Technical Service Bulletin

DATE JULY 31, 1967
 NUMBER 67DT-13 MODEL P200,300,400,C500,L600
 GROUP ENGINE SUBJECT POSITIVE CRANKCASE VENT REQUIRED ON 1968 VEH.
 SUMMARY INSTALLING POSITIVE CRANKCASE VENT SYSTEM ON THE ABOVE MODEL VEHICLES.

POSITIVE CRANKCASE VENT INSTALLATION INSTRUCTIONS

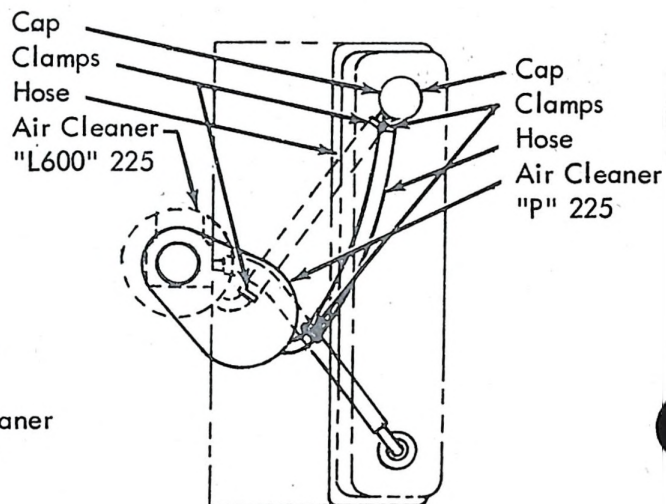
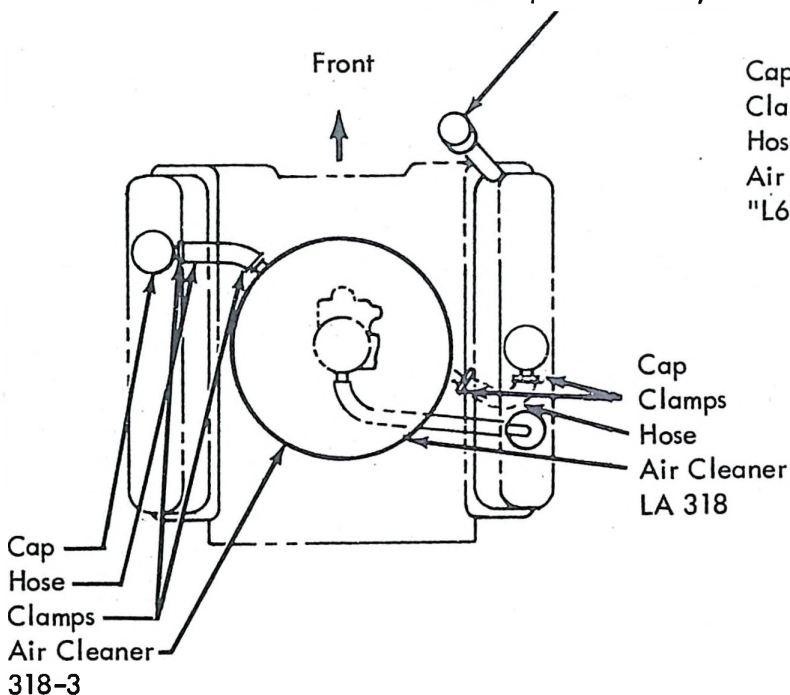
If you encounter vehicles that require the positive crankcase vent system to meet the U. S. Government requirements, a new carburetor air cleaner, hose and clamps, and oil filler cap are required. The service part number chart and engine schematic on reverse side will be helpful to perform the conversion. These parts are available from MoPar Parts Division.

1. Install new air cleaner and oil filler cap.
2. Cut #1930 488 (5/8 I.D.) hose as required to neatly dress air cleaner to filler cap.
3. Install hose using 111606 clamp at each end.
